RE: LFPCN 41357 - Littelfuse TVS DO-214AB Package Lead Frame Optimization

Product/Process Change Notice (PCN)

PCN#: LFPCN #41357 **Date:** Aug 25th, 2020

Prepared By : Hellen Yang – Sr. Product Engineer,
Date : 8/18/2020
Device : DO-214AB Leadframe molding lock & V groove optimization
Revision : A

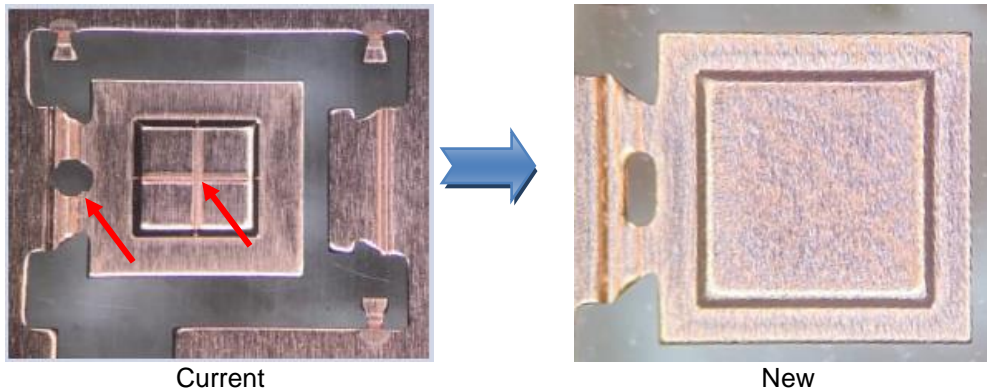
The purpose of this project is to qualify DO-214AB TVS with optimized leadframe mold lock design & remove V groove to reduce trim & form stress and soldering stress. Succeeding pages summarize the material and reliability test performed in qualification lots.

3.0 Assembly, Process & Material Differences/Changes:

3.2 Material Changes
